## RESPONSE TO REQUEST FOR ADDITIONAL INFORMATION

### APR1400 Design Certification

RAI No.: 475-8596  
SRP Section: 10.04.08 – Steam Generator Blowdown System  
Application Section: 10.4.8  
Date of RAI Issue: 05/04/2016

### **Question No. 10.04.08-6**

Figure 2.7.1.8-1 Steam Generator Blowdown System

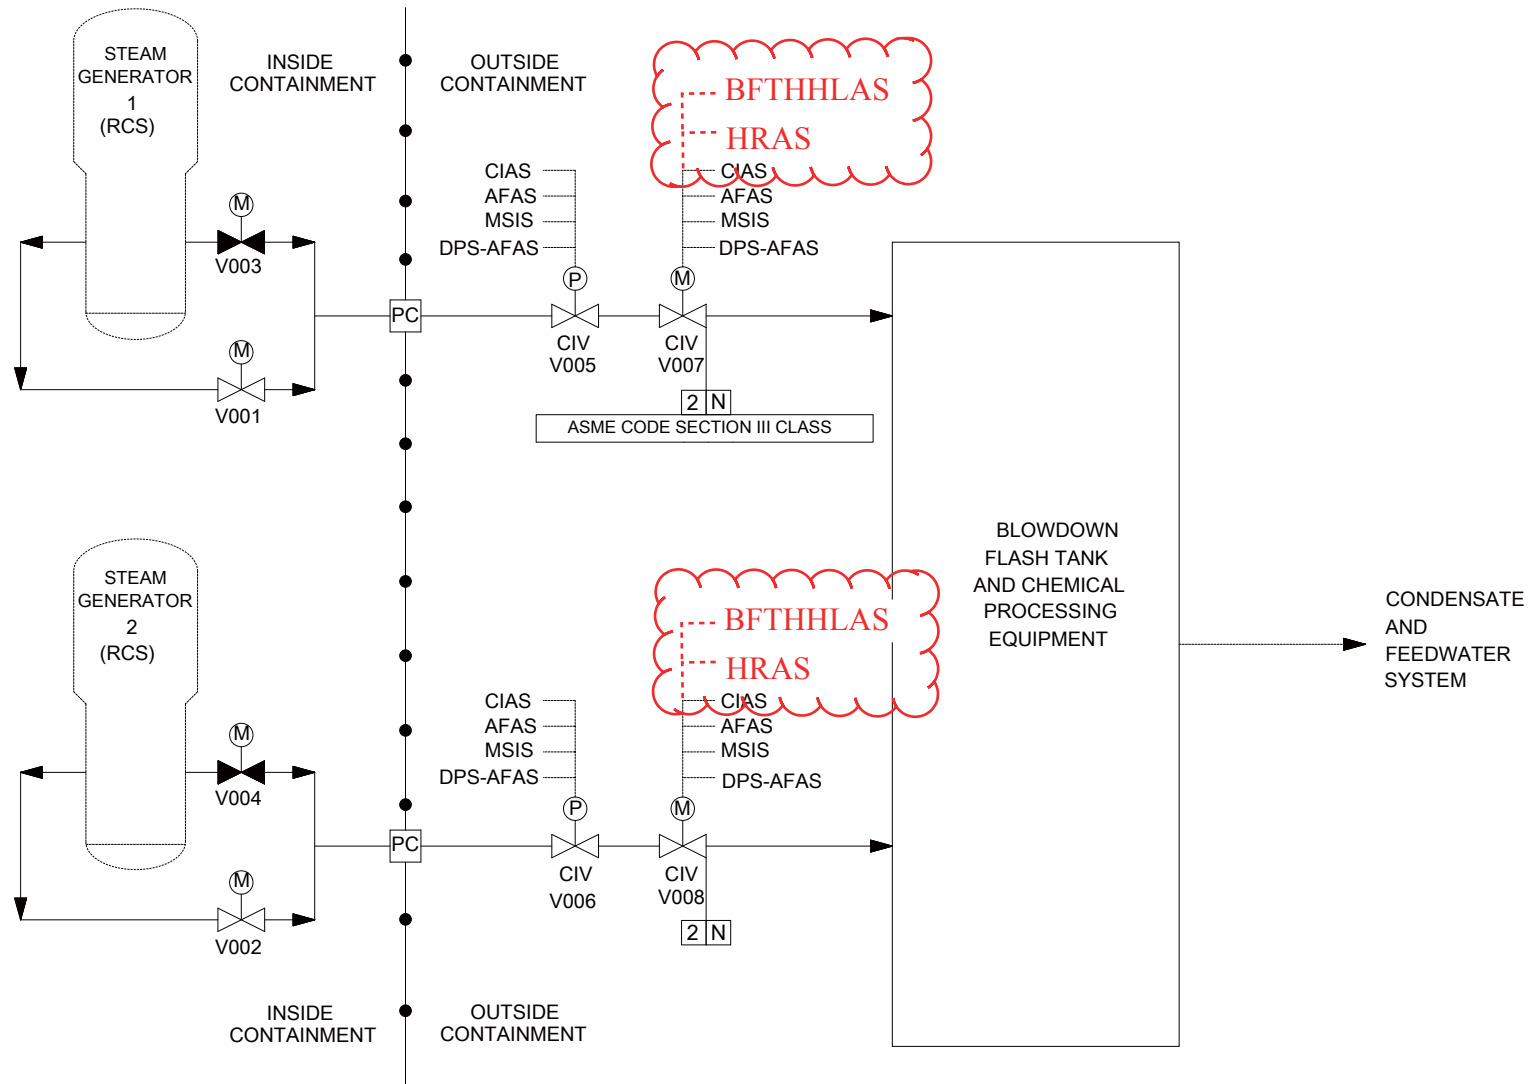
- a. The response proposes listing additional control signals in Tier 1 Table 2.7.1.8-1, but there is no corresponding change proposed for Tier 1 Figure 2.7.1.8-1. Since Figure 2.7.1.8-1 shows the control signals associated with containment isolation valves, provide your plans for revising Figure 2.7.1.8-1 or the basis for not revising it.
- b. The response indicates that Tier 2 Chapter 7 intentionally discusses the instrumentation and controls at a higher level and does not describe individual signals. The staff determined that for consistency and clarity, the signals that activate the containment isolation valves should be identified in Chapter 7, especially in the functional diagrams. Please discuss your plans to add this information to the FSAR.

- a. DCD Tier 1 Figure 2.7.1.8-1 and ACRONYM AND ABBREVIATION LIST will be revised to include the HRAS and the BFTHHLAS signals as indicated in the Attachment. And the signal lines in DCD Tier 2 Figure 10.4.8-1 will be revised to a dashed line as indicated in the Attachment.
- b. To activate the containment isolation valves (CIVs), following signals are used:
  1. ESFAS (e.g., SIAS, CSAS, CIAS, MSIS, and AFAS) and DPS (e.g., DPS-AFAS) signals

For example, steam generator blowdown system CIVs 005, 006, 007, and 008 in Figure 2.7.1.8-1 of DCD Tier 1 are actuated by the CIAS, AFAS, MSIS, and DPS-SIAS. However, those CIVs are not related with the SIAS and CSAS.
